Design Feedback

March 20th 2016

Move Sensors Far Away From Bond

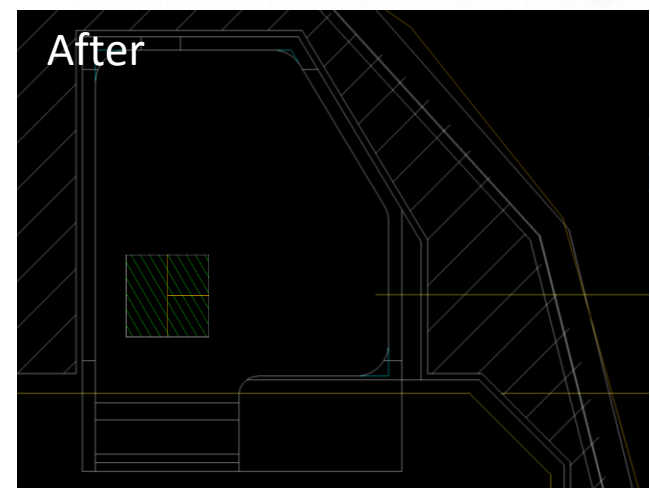
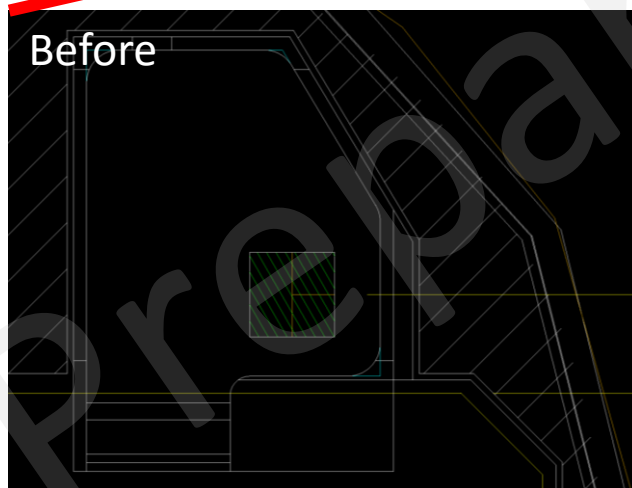
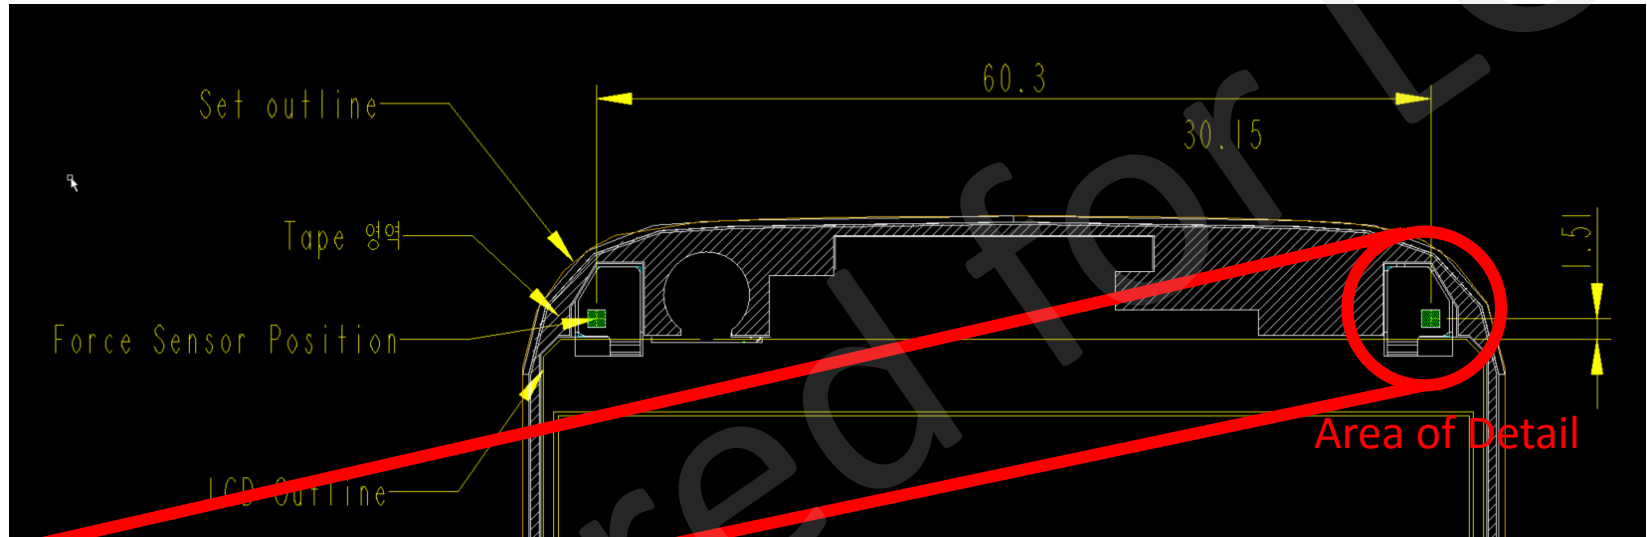
Move Sensors Far Away From Bond

Minimize Bond Area

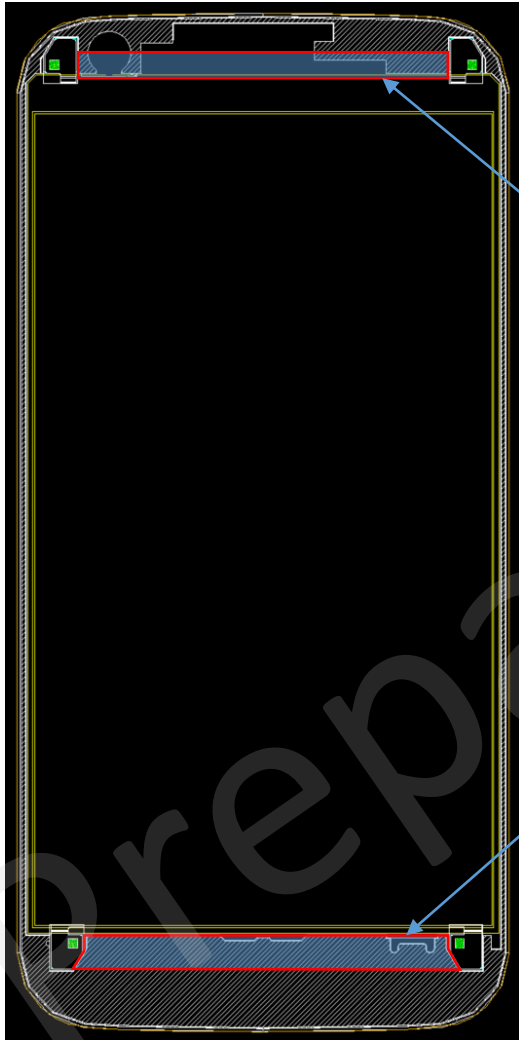
Remove this bond area and the plastic material underneath it to minimize shunt forces and ensure glass does not “bottom out” on plastic

Avoid “Bottoming Out” Display

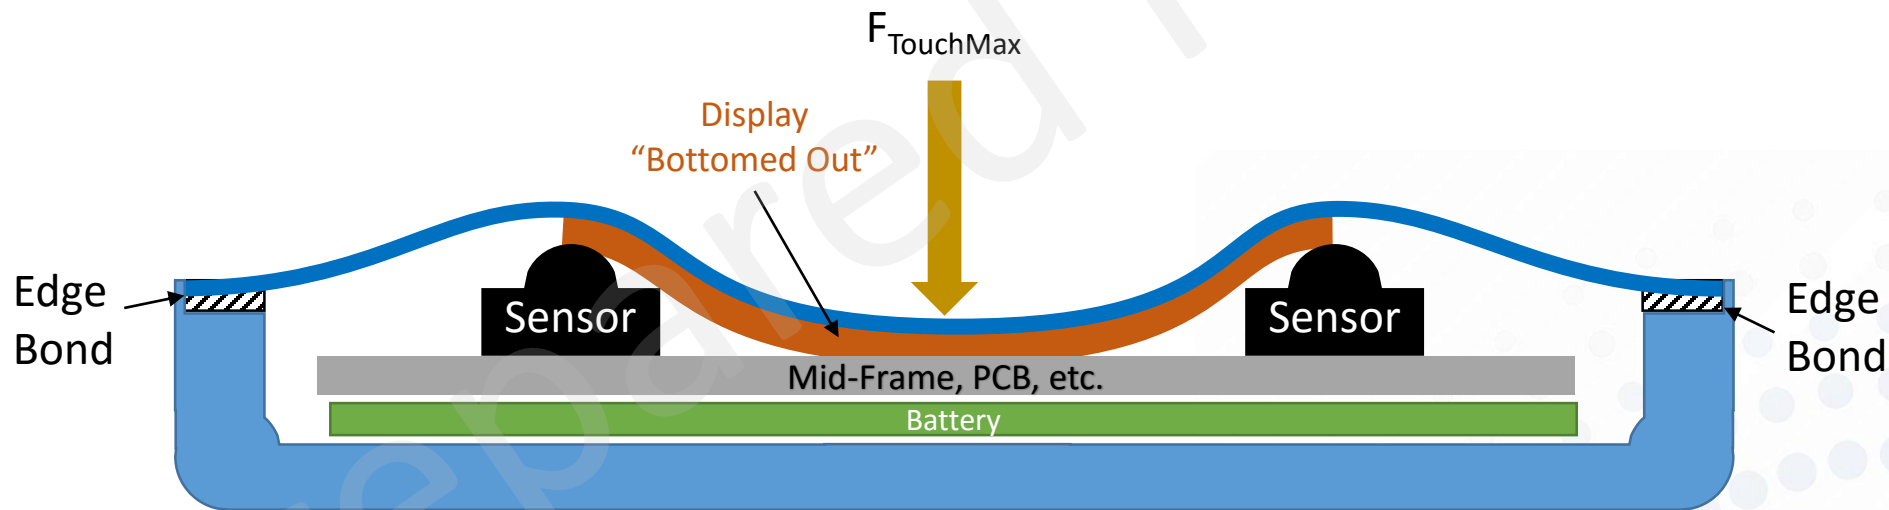
Min Gap must be engineered so that at F_{TouchMax} in the center of the glass, display does not touch any other part:

Cross Section A-A:

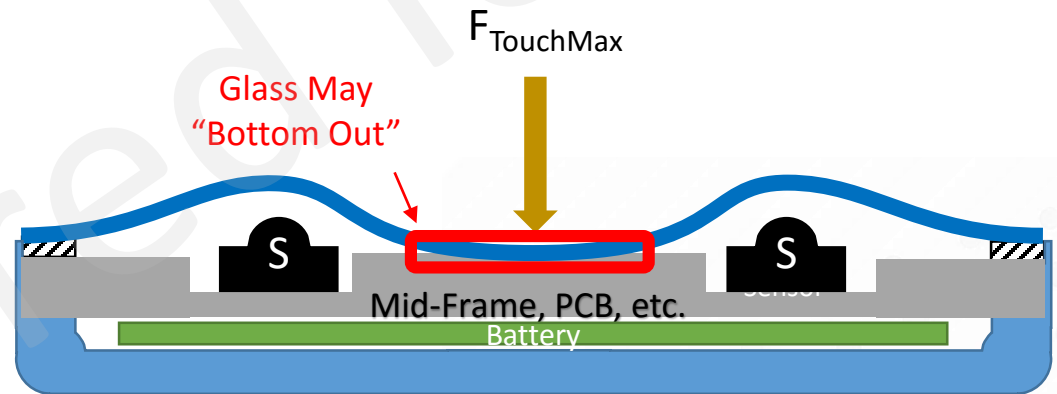
Avoid “Bottoming Out” Glass
